UNITED STATES PATENT AND TRADEMARK OFFICE

APPLICATION NO.	FILING DATE	FIRST NAMED INVENTOR	ATTORNEY DOCKET NO.	CONFIRMATION NO.
10/673,053	09/26/2003	Rainer Bruchhaus	14580-031001	1239

Office Action Summary

REMARK / ARGUMENT

FIG. 18

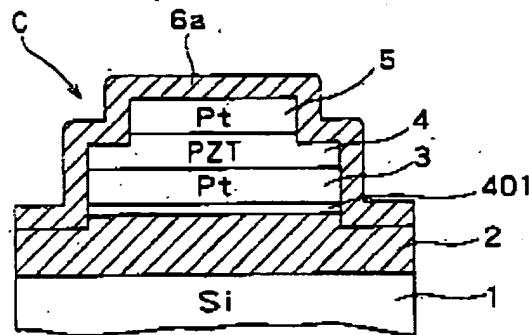
Kanaya discloses a method of forming a ferroelectric capacitor comprising forming a crystalline PZT layer as claimed. **See all the FIGS** where Kanaya teaches the following limitations

10. Pertaining to claim 1, Kanaya discloses a method of forming a ferroelectric capacitor comprising forming a crystalline PZT layer by a process including the steps of:

depositing a layer of amorphous ferroelectric material 4 over a layer of a first material 3;

etching the ferroelectric layer to form isolated ferroelectric elements (**See Fig 1 & 2, column 1 Paragraph [0018] ,please note briefly explain about etching process) ;**

providing a layer of a second material **5 & 6** on at least the side surfaces of the ferroelectric elements; and

performing an annealing step to crystallize the ferroelectric material (**Column 7 Paragraph [0129] Lines 4–7**);

the second material **5 & 6** promoting crystallization of the ferroelectric material to a higher degree than the first material **3**;

whereby the crystallization proceeds horizontally through the ferroelectric elements (**Please note thermal annealing process initiates to form a crystallization on ferroelectric material**) .
